#### **Addendum 151 – UN Regulation No. 152**

#### **Amendment 4**

Supplement 3 to the original version of the Regulation – Date of entry into force:  
30 September 2021

#### **Uniform provisions concerning the approval of motor vehicles with regard to the Advanced Emergency Braking System (AEBS) for M<sub>1</sub> and N<sub>1</sub> vehicles**

Figure 1

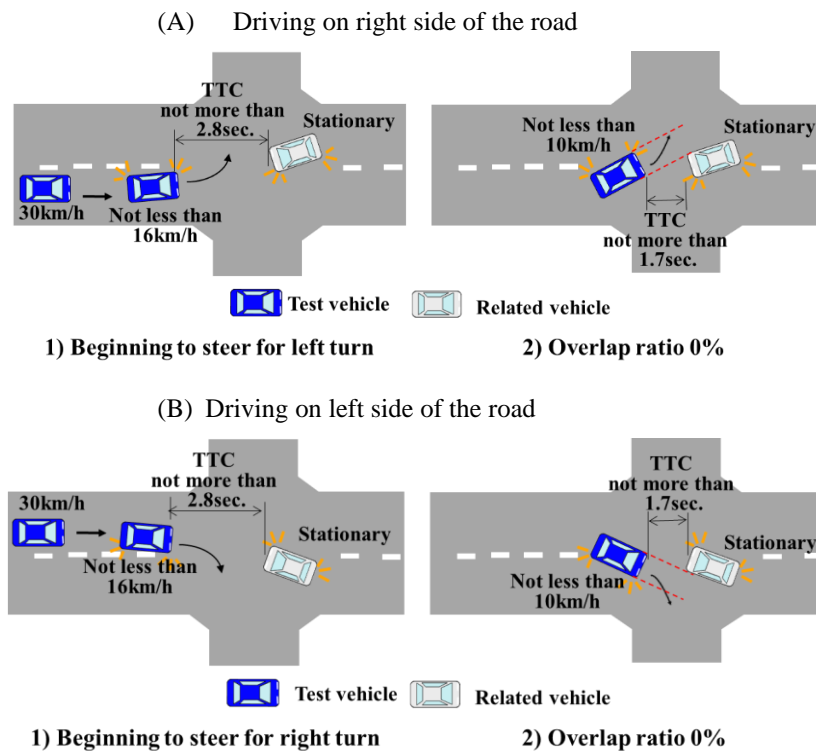
*Insert new Scenarios 1 to 4, to read:*

- 1.1. In this scenario, the subject vehicle passes by a left turn or right turn in front of an oncoming vehicle that is stopped to make a left turn or right turn at an intersection.

The subject vehicle drives at a speed of 30 km/h (with a tolerance of +0/-2 km/h) toward the intersection, and decelerates by braking to a speed of not less than 16 km/h at a point where the subject vehicle begins to steer left / right, and the Time To Collision (TTC) to the oncoming vehicle is not more than 2.8 seconds. When the subject vehicle turns left or right in the intersection, the speed is reduced to not less than 10 km/h, and then drives at a constant speed. The TTC to the oncoming vehicle is not more than 1.7 seconds at when the overlap ratio between the subject vehicle and the oncoming vehicle becomes 0 per cent.

Figure 2  
**Right turn or left turn of a forward vehicle**

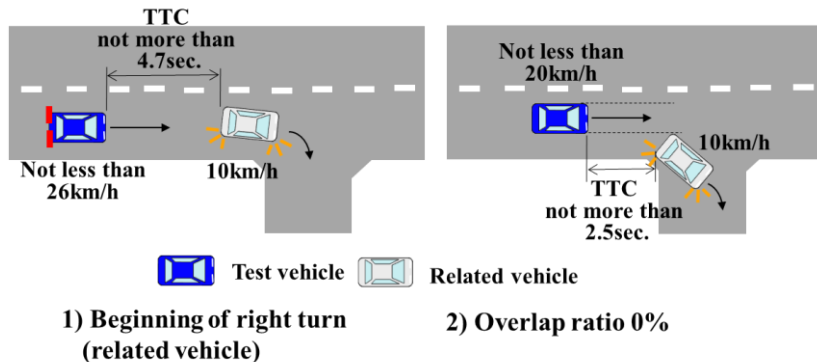
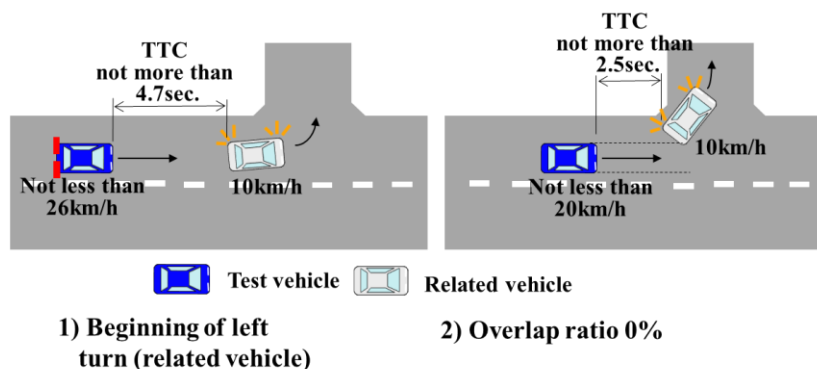
- 2.1. In this scenario, the subject vehicle follows a forward vehicle. After that, the forward vehicle turns right or left at a corner, and the subject vehicle goes straight.
- 2.2. An example of the detail scenario:

Both the forward vehicle and the subject vehicle drive at a speed of 40 km/h (with a tolerance of +0/-2 km/h) on the straight road. The forward vehicle decelerates by braking to a speed of 10 km/h (with a tolerance of +0/-2 km/h) in order to turn right or left at the corner, and the subject vehicle also decelerates by braking to keep appropriate distance with the forward vehicle. At when the forward vehicle begins to turn right or left, the speed of the subject vehicle is not less than 26 km/h and the TTC to the frontal vehicle is not more than 4.7 seconds. After that, the subject vehicle decelerates to a speed of not less than 20 km/h, and then drives at a constant speed. The TTC to the forward vehicle is not more than 2.5 seconds at when the overlap ratio between the subject vehicle and the forward vehicle becomes 0 per cent.

Figure 3  
Curved road with guard pipes and a stationary object

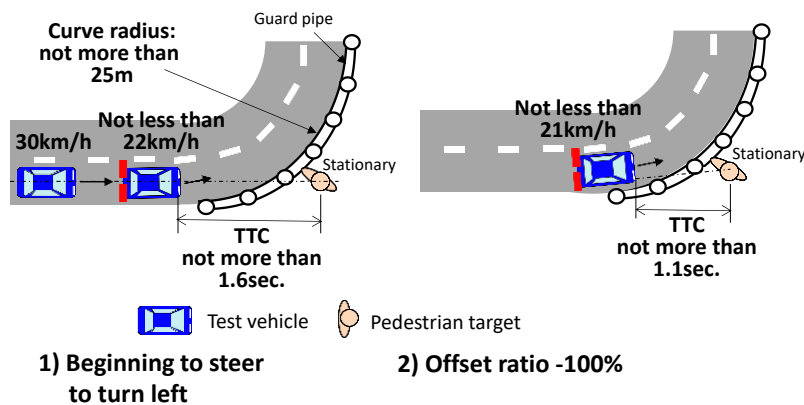
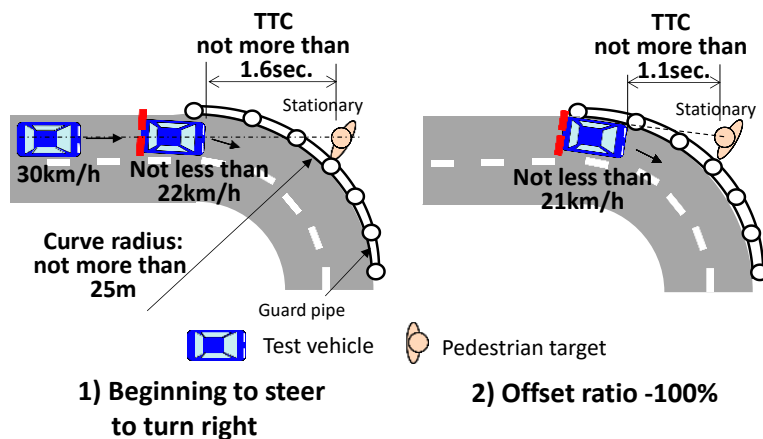
- 3.1. In this scenario, the subject vehicle drives a small radius curved road of which the guard pipes are constructed to the outer side, and a stationary vehicle (M<sub>1</sub> category), a stationary pedestrian target or a stationary bicycle target is positioned just outside of the guard pipes and where on the extension of the centre of the lane.
- 3.2. An example of the detail scenario:

The subject vehicle drives at a speed of 30 (with a tolerance of +0/-2 km/h) km/h toward the curve of which the radius is not more than 25 m at the outer side of the road, and decelerates by braking to a speed of not less than 22 km/h at a point where the subject vehicle enters the curve. The TTC to the stationary object is not more than 1.6 seconds at when the subject vehicle begins to turn in the curve. In the curve, the subject vehicle drives outer lane than the centre of the road. After that, the subject vehicle continue to turn in the curve at a constant speed of not less than 21 km/h. The TTC to the stationary object is not more than 1.1 second at when the overlap ratio between the subject vehicle and the stationary vehicle becomes 0 %, or at when the offset ratio between the subject vehicle and the centre of the stationary pedestrian target or the stationary bicycle target becomes -100 per cent.

Figure 4  
Lane change due to road construction

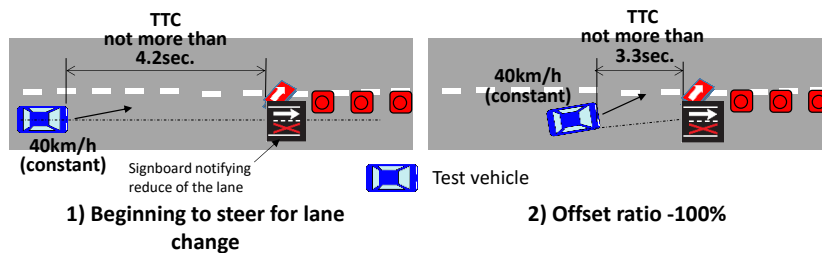
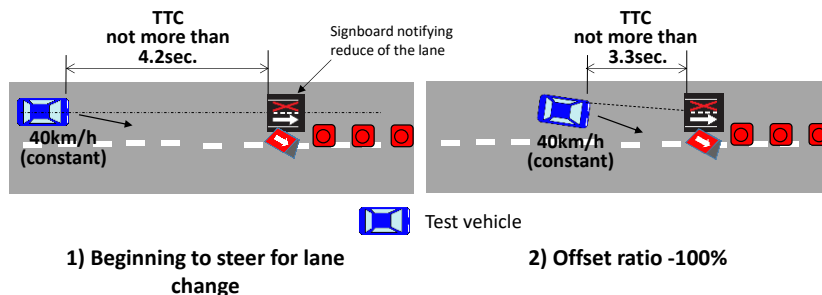
- 4.1. In this scenario, the subject vehicle changes the lane in front of the signboard which is positioned in the centre of the lane and notifies the driver that the lane is reduced.
- 4.2. An example of the detail scenario:

The subject vehicle drives a straight road at a speed of 40 km/h (with a tolerance of  $\pm 2$  km/h), and begins to steer in order to change the lane in front of the signboard which notifies reducing the lane. No other vehicles approach the subject vehicle. The TTC to the signboard is not more than 4.2 seconds at when the subject vehicle begins to steer. During changing the lane, the speed of the subject vehicle is constant, and the TTC to the signboard is not more than 3.3 seconds at when the offset ratio between the subject vehicle and the centre of the signboard becomes -100 per cent.
